178 Regent's Park Road 2019/6009/P – Site plan

Delegated Report		Analysis sheet	Expiry Date:	27/01/2020
(Members Briefing)		N/A	Consultation Expiry Date:	10/02/2020
Officer			Application Number(s)	
Rachel English			2019/6009/P	
Application Address			Drawing Numbers	
178 Regent's Park Road London NW1 8XP			Please see decision notice	
PO 3/4	Area Team Signature	C&UD	Authorised Officer Signature	
Proposal(s)				
Erection of replacement lower ground floor rear extension, replacement of first floor rear extension and creation of green roofs at upper ground and first floor levels. Partial rebuild and raise height of rear closet wing extension. Replacement of uPVC windows and doors with timber windows and doors. Replacement of part roof with hip. Removal of dormer window to front roofslope, insertion of replacement solar panels and new rooflights.				
Recommendation(s):		Grant conditional planning permission		
Application Type:		Full Planning Permission

Application ref: 2019/6009/P
Contact: Rachel English
Tel: 020 7974 2726
Date: 15 April 2020

Proposed rear elevation

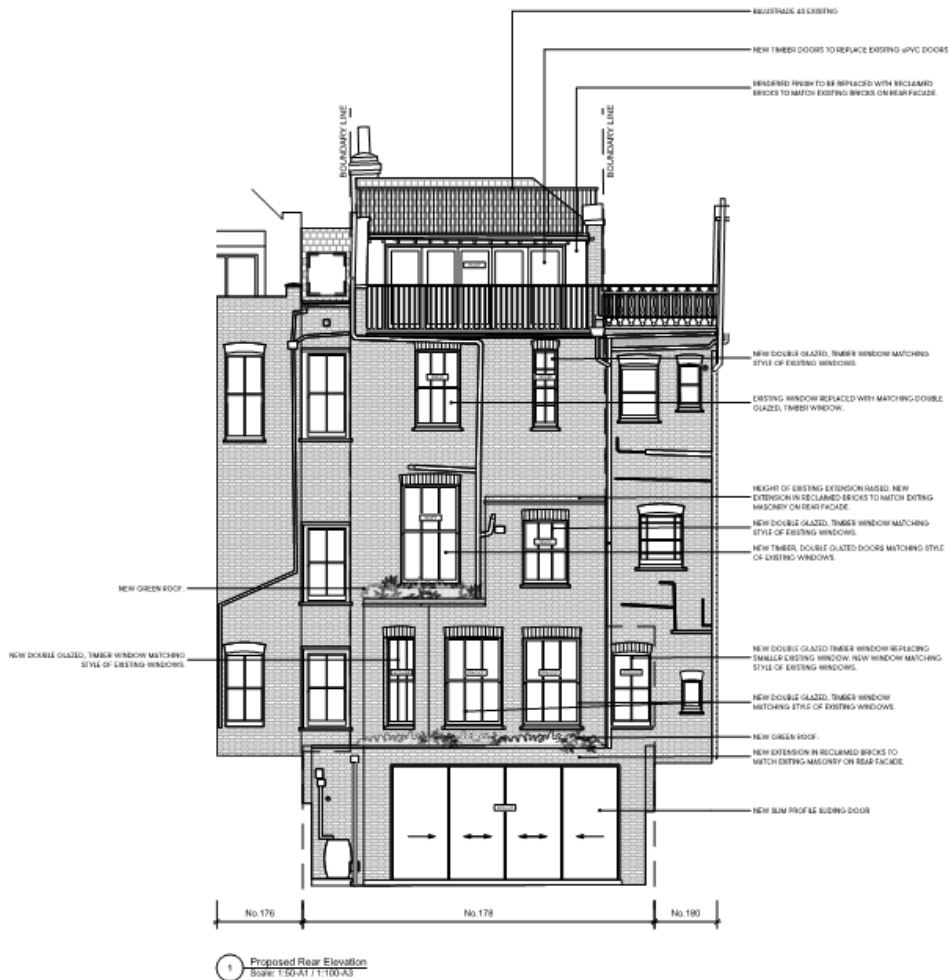
CAAC comments:	<p>PRIMROSE HILL Conservation Area Advisory Committee (CAAC) object to the application on the following grounds:</p> <ol style="list-style-type: none"> 1) We object to the proposed balcony at the rear at first floor level on the grounds of overlooking of neighbours private amenity space. 2) We do not object to the reconfiguring of the back addition at lower ground and first floors. 3) On the front elevation we seek to ensure that the frames, glazing bars and mouldings, in scale, form and thickness, of the proposed double glazed windows exactly match the originals. This house is part of a group and the details should be consistent. 4) We seek to ensure that the stone used in the paving is low carbon in terms of its transport, and that the paving is permeable and allows natural drainage. 5) Given the scale of the work and the location of the house, in mid-terrace, we request that a Construction Management Plan (CMP) is legally agreed and enforceable. <p><u>Officer response</u></p> <ol style="list-style-type: none"> 1) The proposals have been revised following Officer advice and the rear balcony has now been removed from the proposals 2) Noted 3) Noted. The front windows are shown on the drawings as matching the existing ones. 4) Noted and an informative is added to the decision requesting this. 5) Paragraph 6.13 of the Camden Local Plan states that CMPs are required for major developments, basement developments,

Following Officer comments, the proposals have been revised and the Primrose Hill CAAC have withdrawn their objection as the rear balcony has been removed. They do however request:

2.3 Following Officer advice the scale of changes to the rear façade have been reduced. The property already contains a closet wing which the rest of this part of the terrace do not. Increasing its size by 1800mm was considered to bring undue prominence and be out of character with the rest of the terrace and have an adverse effect on this part of the Conservation Area. Officers have now negotiated a 700mm increase in height which would have a minimal visual change and would ensure that the closet wing remains subordinate to the existing dwelling, thereby retaining the integrity of the building.

3.2 Following Officer advice the terrace at rear upper ground floor level has been removed from the proposals in order to reduce loss of overlooking, a concern raised by objectors. A condition is added to ensure that the flat roofs are used for access only for maintenance for the green roofs. The roof terraces at roof level are as existing. One new window would be inserted into the closet wing at first floor level. This would serve a bathroom and would not give rise to any direct overlooking impact for nearby residential occupiers. The proposals would not give rise to any further overlooking of 1 Berkley Street, located to the rear of the site, over and above that which already exists.

- i) remove the terraces at upper ground and first floor levels and replace with green roofs;
- ii) reduce the height increase of the closet wing to 700mm;
- iii) amend the design of the rear upper ground floor fenestration to install timber framed, sash windows;
